## **Staff Changes**

This section covers changes proposed by Planning Staff to correct errors and to reflect changes in conversion philosophy based on discussions with the PHED Committee and the Planning Board.

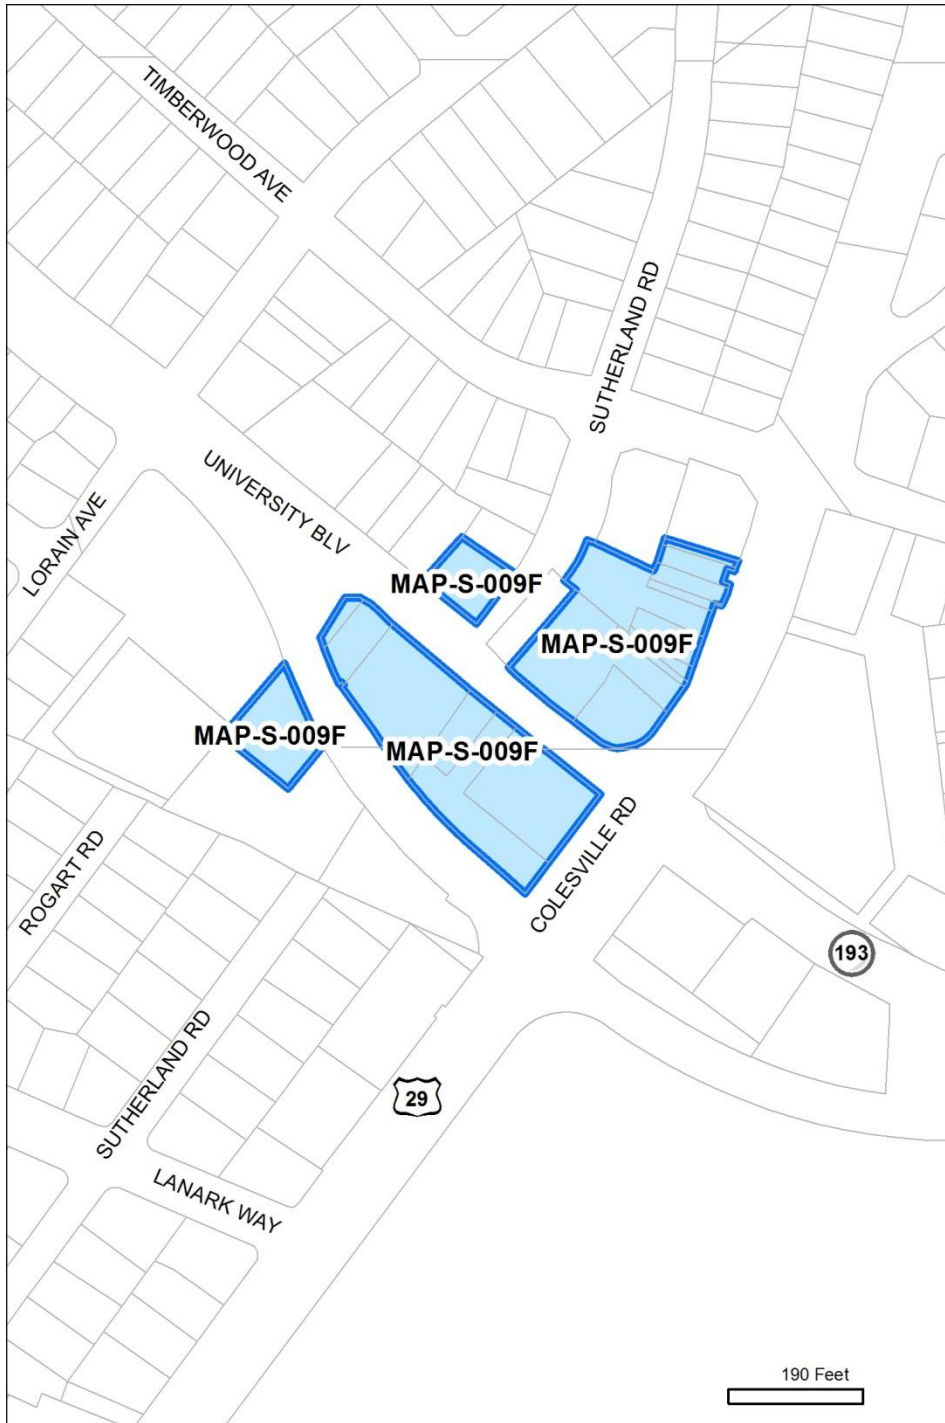
<b>Unique ID:</b> MAP-S-009F		staff rec. change
<b>Master Plan ID:</b> n/a		
<b>Master Plan:</b>	Four Corners	
<b>Location:</b>	Four Corners	
<b>Existing Zone:</b>	C-2	
<b>Proposed Conv:</b> (5/2)	CRT-2.5 C-1.5 R-1.5 H-75	
<b>Prop. Revised Conv:</b>	CRT-2.25 C-1.5 R-0.75 H-75	
<b>Category:</b>	Staff Recommendation	
<b>Modifications</b>	<b>Zone Group:</b>	No change
	<b>Overall FAR:</b>	Reduced to 2.25
	<b>Comm'l FAR:</b>	No change
	<b>Resid'l FAR:</b>	Reduced to 0.75
	<b>Height:</b>	No change
<b>Reason for change:</b>		
<p>Since the 5/2 conversion, further staff analysis indicated that residential development in the C-2 zone is essentially limited to around 0.75 FAR. As a result, the Planning Board recommended reducing allowed residential FAR to 0.75, following its review of DMA-956. The PHED Committee agrees with this recommendation.</p> <p>With the reduction in maximum residential FAR, the total FAR allowed must be reduced to 2.25 FAR.</p>

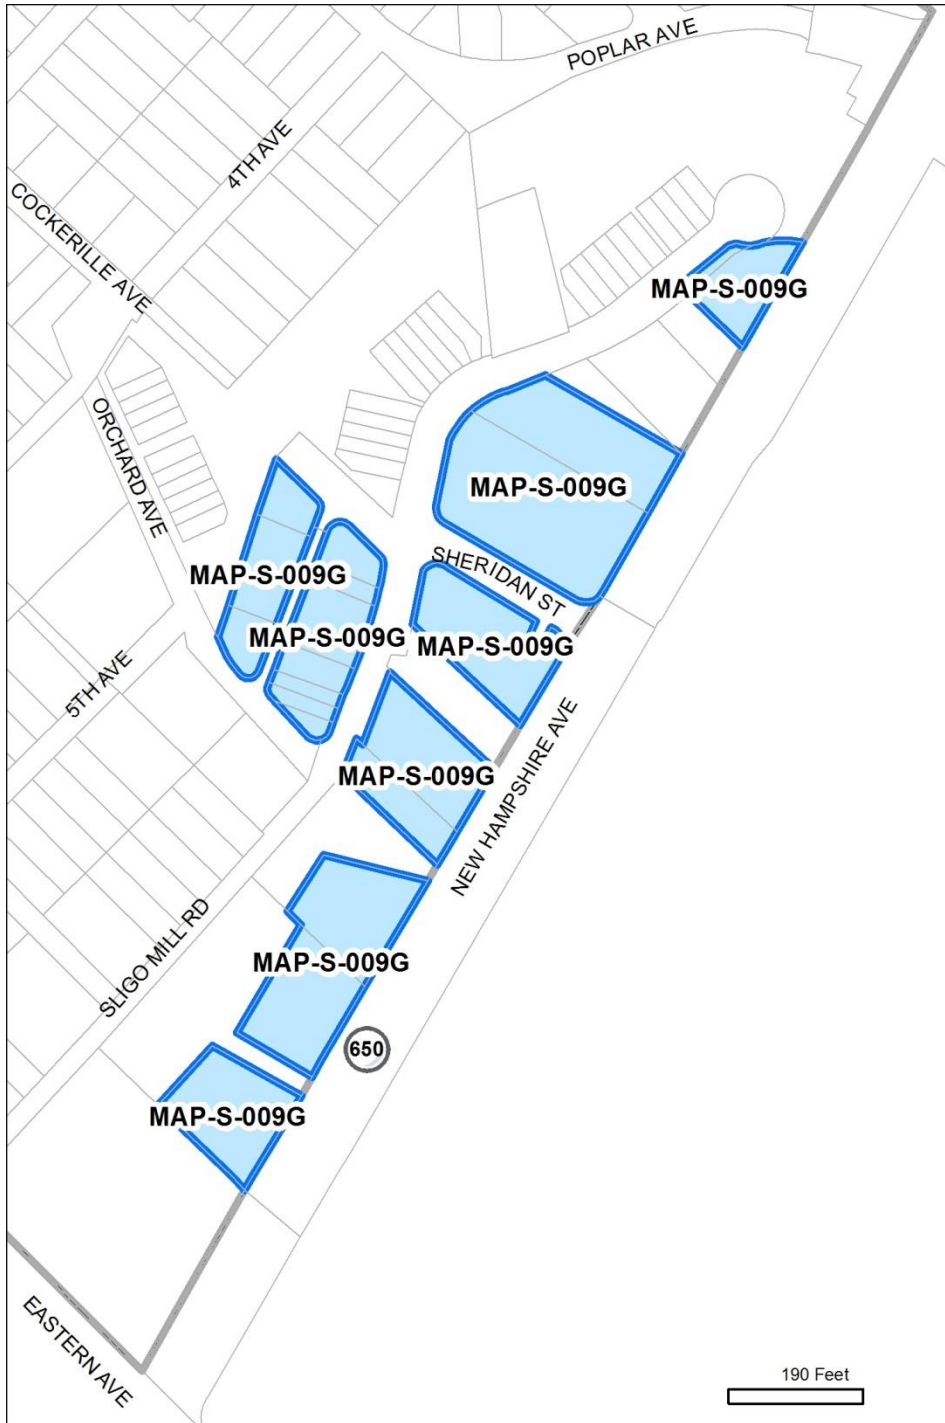
<b>Unique ID:</b> MAP-S-009G		staff rec. change
<b>Master Plan ID:</b> n/a		
<b>Master Plan:</b>	Takoma Park	
<b>Location:</b>	New Hampshire Ave north of Eastern Ave	
<b>Existing Zone:</b>	C-2	
<b>Proposed Conv:</b> (5/2)	CRT-2.5 C-1.5 R-1.5 H-75	
<b>Prop. Revised Conv:</b>	CRT-2.25 C-1.5 R-0.75 H-75	
<b>Category:</b>	Staff Recommendation	
<b>Modifications</b>	<b>Zone Group:</b>	No change
	<b>Overall FAR:</b>	Reduced to 2.25
	<b>Comm'l FAR:</b>	No change
	<b>Resid'l FAR:</b>	Reduced to 0.75
	<b>Height:</b>	No change
<b>Reason for change:</b>		
<p>Since the 5/2 conversion, further staff analysis indicated that residential development in the C-2 zone is essentially limited to around 0.75 FAR. As a result, the Planning Board recommended reducing allowed residential FAR to 0.75, following its review of DMA-956. The PHED Committee agrees with this recommendation.</p> <p>With the reduction in maximum residential FAR, the total FAR allowed must be reduced to 2.25 FAR.</p>

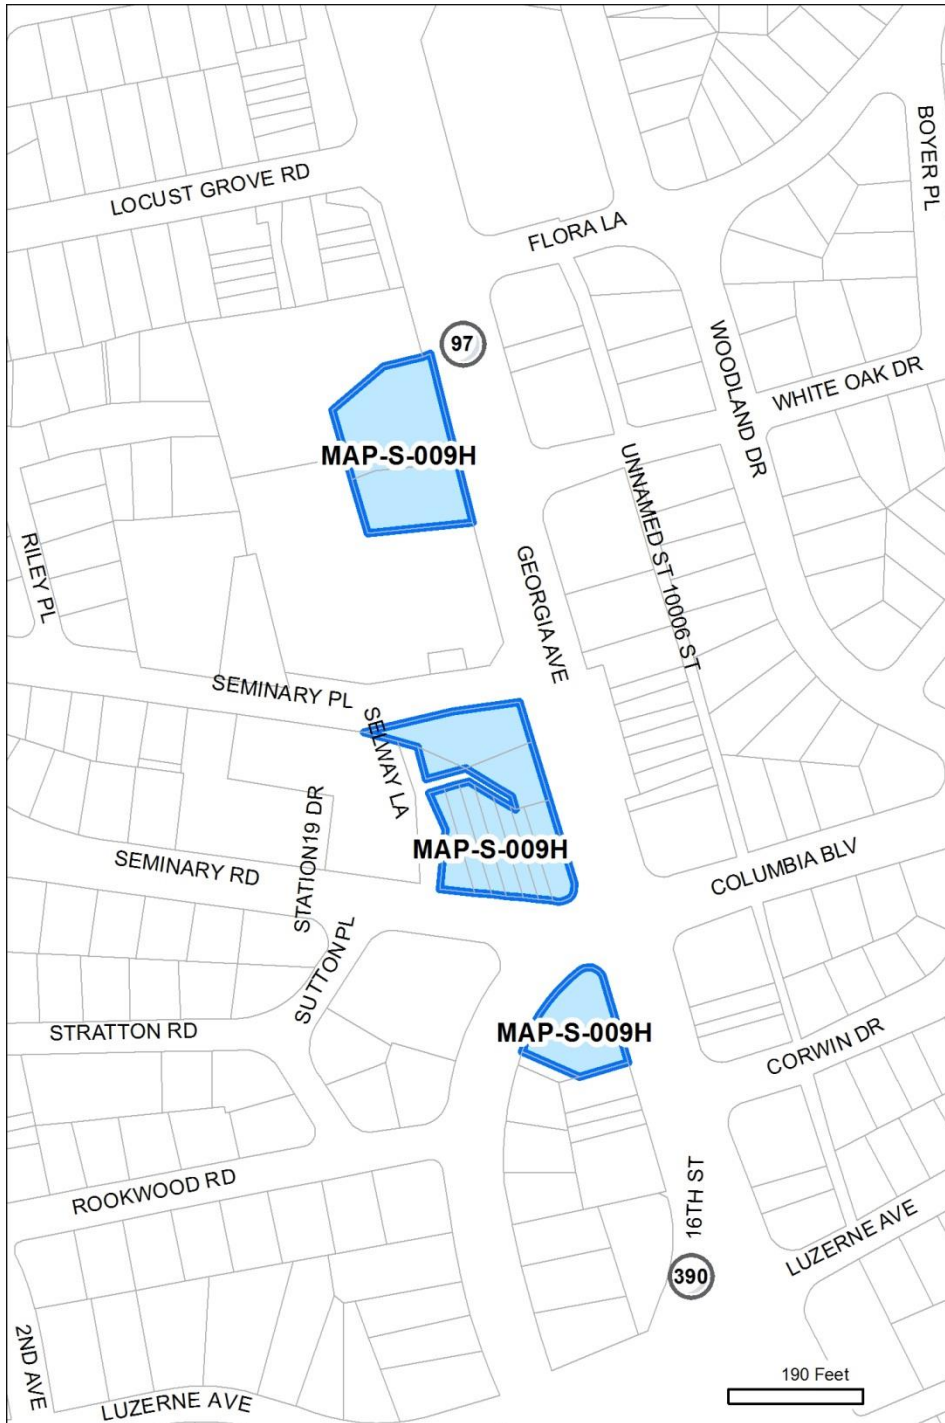
<b>Unique ID:</b> MAP-S-009H		staff rec. change
<b>Master Plan ID:</b> n/a		
<b>Master Plan:</b>	North and West Silver Spring	
<b>Location:</b>	Montgomery Hills	
<b>Existing Zone:</b>	C-2	
<b>Proposed Conv:</b> (5/2)	CRT-2.5 C-1.5 R-1.5 H-75	
<b>Prop. Revised Conv:</b>	CRT-2.25 C-1.5 R-0.75 H-75	
<b>Category:</b>	Staff Recommendation	
<b>Modifications</b>	<b>Zone Group:</b>	No change
	<b>Overall FAR:</b>	Reduced to 2.25
	<b>Comm'l FAR:</b>	No change
	<b>Resid'l FAR:</b>	Reduced to 0.75
	<b>Height:</b>	No change
<b>Reason for change:</b>		
<p>Since the 5/2 conversion, further staff analysis indicated that residential development in the C-2 zone is essentially limited to around 0.75 FAR. As a result, the Planning Board recommended reducing allowed residential FAR to 0.75, following its review of DMA-956. The PHED Committee agrees with this recommendation.</p> <p>With the reduction in maximum residential FAR, the total FAR allowed must be reduced to 2.25 FAR.</p>

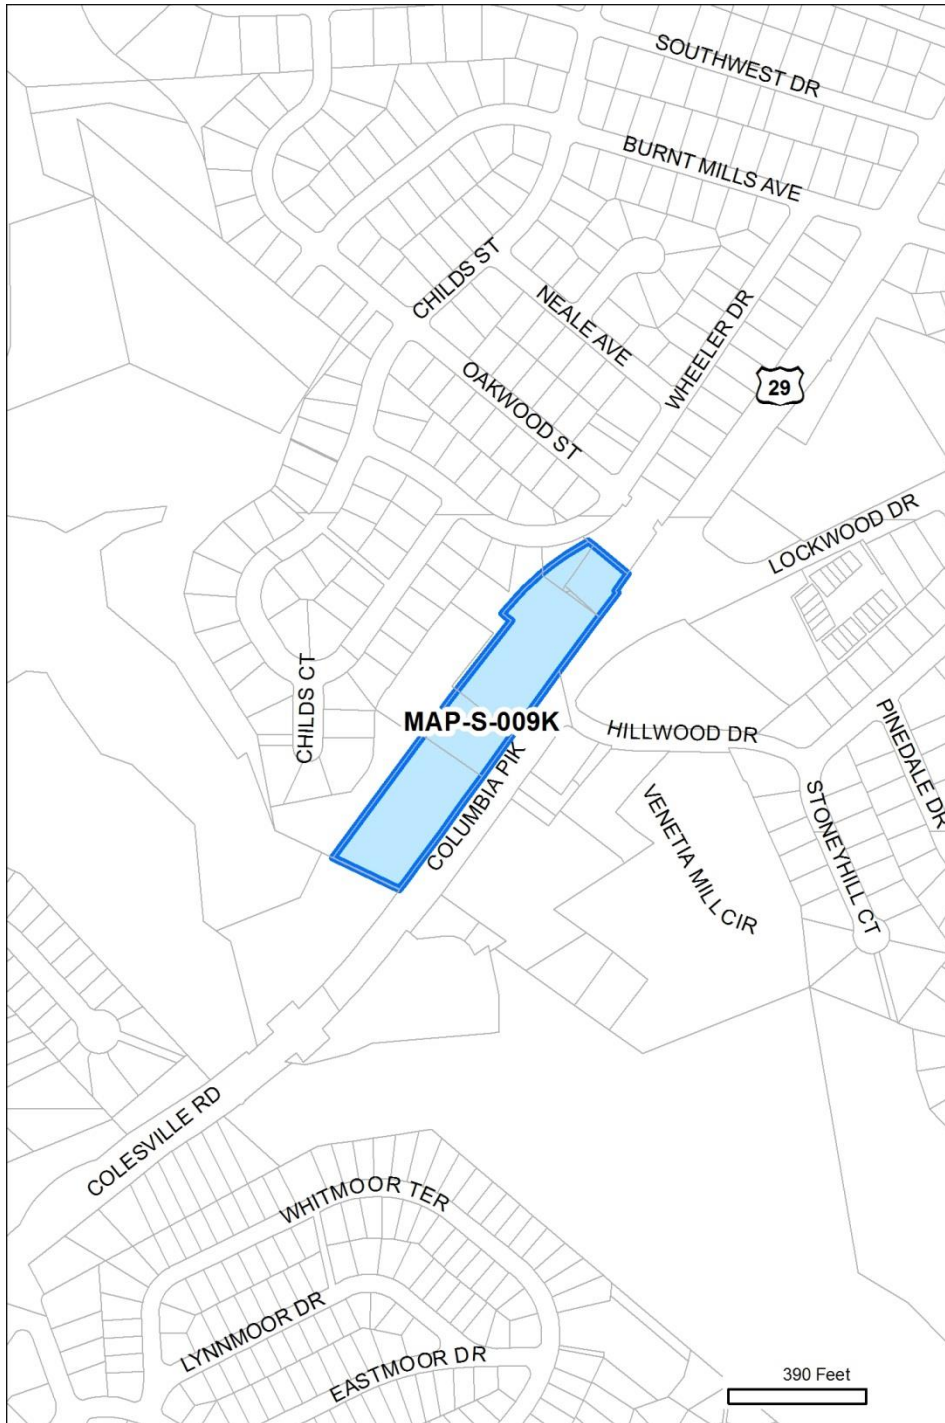
<b>Unique ID:</b> MAP-S-009K		staff rec. change
<b>Master Plan ID:</b> n/a		
<b>Master Plan:</b>	White Oak	
<b>Location:</b>	West side US 29 at Hillwood Dr	
<b>Existing Zone:</b>	C-2	
<b>Proposed Conv:</b> (5/2)	CRT-2.5 C-1.5 R-1.5 H-75	
<b>Prop. Revised Conv:</b>	CRT-2.25 C-1.5 R-0.75 H-75	
<b>Category:</b>	Staff Recommendation	
<b>Modifications</b>	<b>Zone Group:</b>	No change
	<b>Overall FAR:</b>	Reduced to 2.25
	<b>Comm'l FAR:</b>	No change
	<b>Resid'l FAR:</b>	Reduced to 0.75
	<b>Height:</b>	No change
<b>Reason for change:</b>		
<p>Since the 5/2 conversion, further staff analysis indicated that residential development in the C-2 zone is essentially limited to around 0.75 FAR. As a result, the Planning Board recommended reducing allowed residential FAR to 0.75, following its review of DMA-956. The PHED Committee agrees with this recommendation.</p> <p>With the reduction in maximum residential FAR, the total FAR allowed must be reduced to 2.25 FAR.</p>

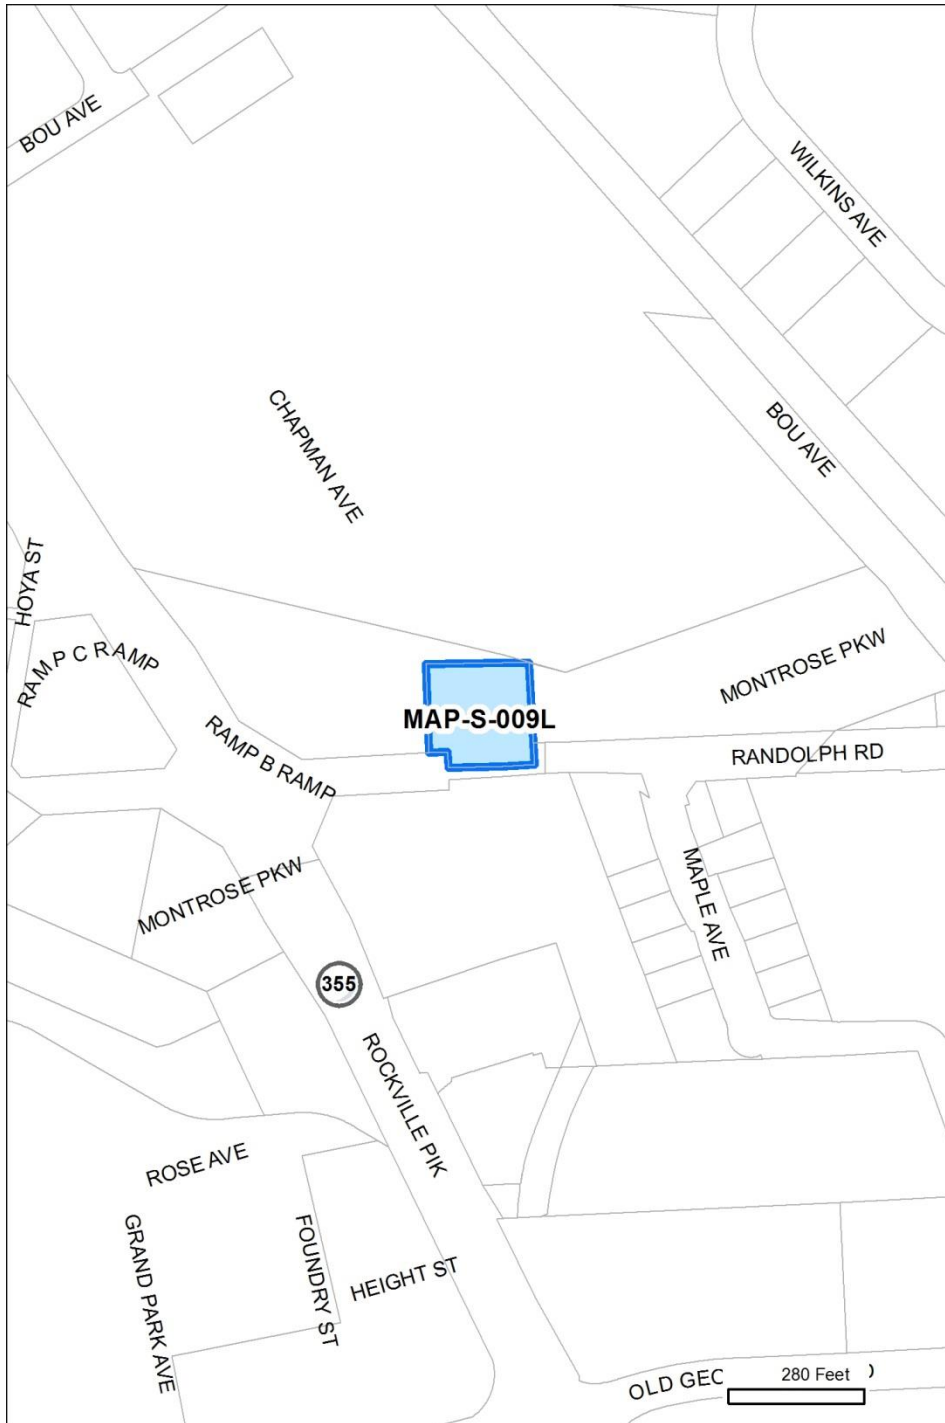
<b>Unique ID:</b> MAP-S-009L		staff rec. change
<b>Master Plan ID:</b> n/a		
<b>Master Plan:</b>	White Flint	
<b>Location:</b>	Montrose School	
<b>Existing Zone:</b>	C-2	
<b>Proposed Conv:</b> (5/2)	CRT-2.5 C-1.5 R-1.5 H-75	
<b>Prop. Revised Conv:</b>	CRT-2.25 C-1.5 R-0.75 H-75	
<b>Category:</b>	Staff Recommendation	
<b>Modifications</b>	<b>Zone Group:</b>	No change
	<b>Overall FAR:</b>	Reduced to 2.25
	<b>Comm'l FAR:</b>	No change
	<b>Resid'l FAR:</b>	Reduced to 0.75
	<b>Height:</b>	No change
<b>Reason for change:</b>		
<p>Since the 5/2 conversion, further staff analysis indicated that residential development in the C-2 zone is essentially limited to around 0.75 FAR. As a result, the Planning Board recommended reducing allowed residential FAR to 0.75, following its review of DMA-956. The PHED Committee agrees with this recommendation.</p> <p>With the reduction in maximum residential FAR, the total FAR allowed must be reduced to 2.25 FAR.</p>

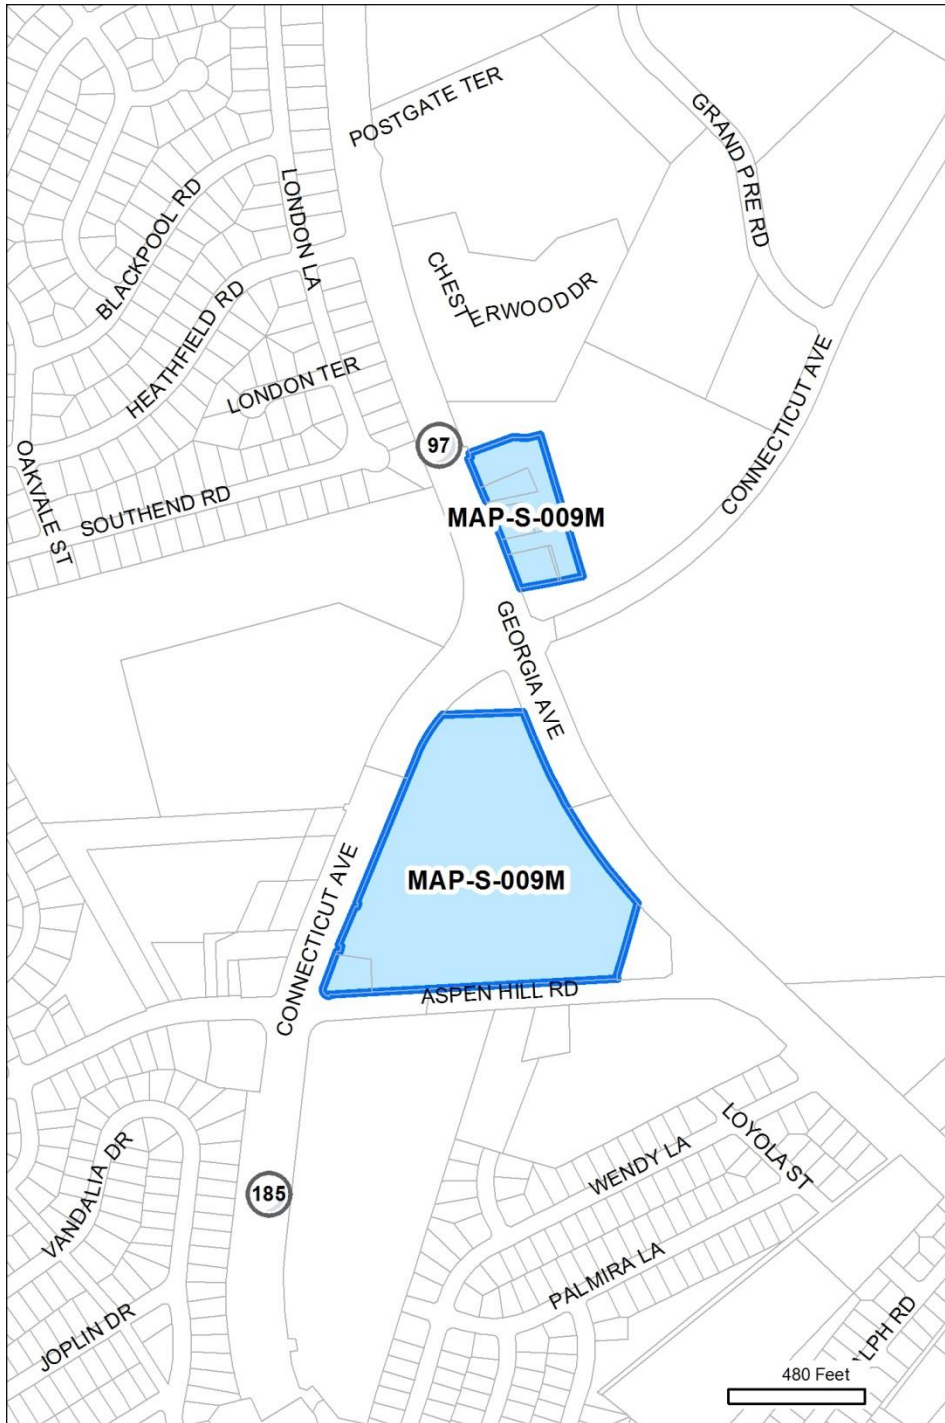
<b>Unique ID:</b> MAP-S-009M		staff rec. change
<b>Master Plan ID:</b> n/a		
<b>Master Plan:</b>	Aspen Hill	
<b>Location:</b>	Aspen Hill	
<b>Existing Zone:</b>	C-2	
<b>Proposed Conv:</b> (5/2)	CRT-2.5 C-1.5 R-1.5 H-75	
<b>Prop. Revised Conv:</b>	CRT-2.25 C-1.5 R-0.75 H-75	
<b>Category:</b>	Staff Recommendation	
<b>Modifications</b>	<b>Zone Group:</b>	No change
	<b>Overall FAR:</b>	Reduced to 2.25
	<b>Comm'l FAR:</b>	No change
	<b>Resid'l FAR:</b>	Reduced to 0.75
	<b>Height:</b>	No change
<b>Reason for change:</b>		
<p>Since the 5/2 conversion, further staff analysis indicated that residential development in the C-2 zone is essentially limited to around 0.75 FAR. As a result, the Planning Board recommended reducing allowed residential FAR to 0.75, following its review of DMA-956. The PHED Committee agrees with this recommendation.</p> <p>With the reduction in maximum residential FAR, the total FAR allowed must be reduced to 2.25 FAR.</p>

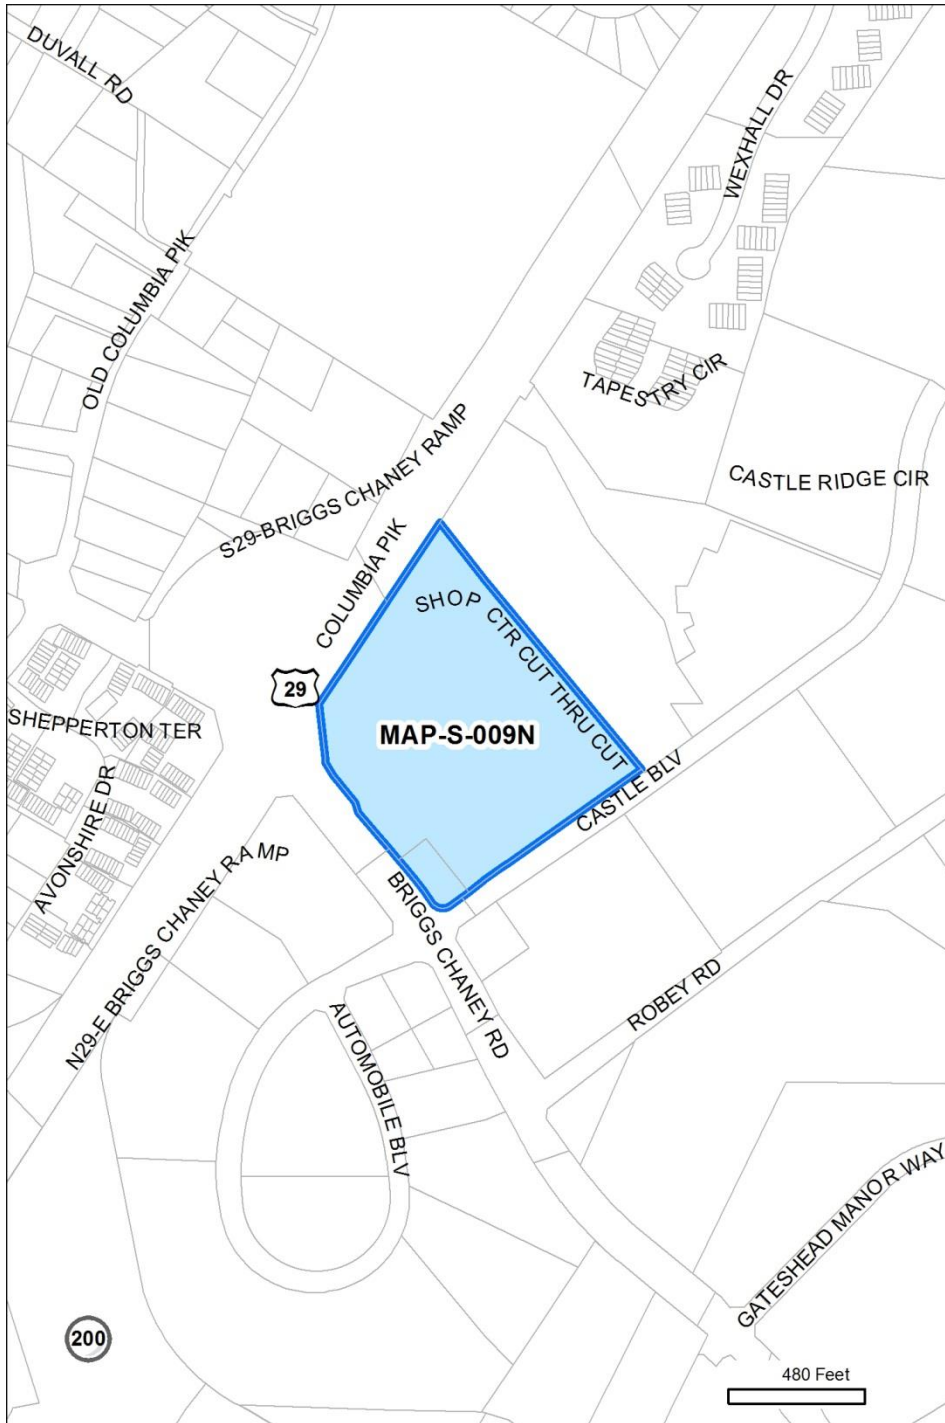
<b>Unique ID:</b> MAP-S-009N		staff rec. change
<b>Master Plan ID:</b> n/a		
<b>Master Plan:</b>	Fairland	
<b>Location:</b>	NE corner of US 29 and Briggs Chaney	
<b>Existing Zone:</b>	C-2	
<b>Proposed Conv:</b> (5/2)	CRT-2.5 C-1.5 R-1.5 H-75	
<b>Prop. Revised Conv:</b>	CRT-2.25 C-1.5 R-0.75 H-75	
<b>Category:</b>	Staff Recommendation	
<b>Modifications</b>	<b>Zone Group:</b>	No change
	<b>Overall FAR:</b>	Reduced to 2.25
	<b>Comm'l FAR:</b>	No change
	<b>Resid'l FAR:</b>	Reduced to 0.75
	<b>Height:</b>	No change
<b>Reason for change:</b>		
<p>Since the 5/2 conversion, further staff analysis indicated that residential development in the C-2 zone is essentially limited to around 0.75 FAR. As a result, the Planning Board recommended reducing allowed residential FAR to 0.75, following its review of DMA-956. The PHED Committee agrees with this recommendation.</p> <p>With the reduction in maximum residential FAR, the total FAR allowed must be reduced to 2.25 FAR.</p>
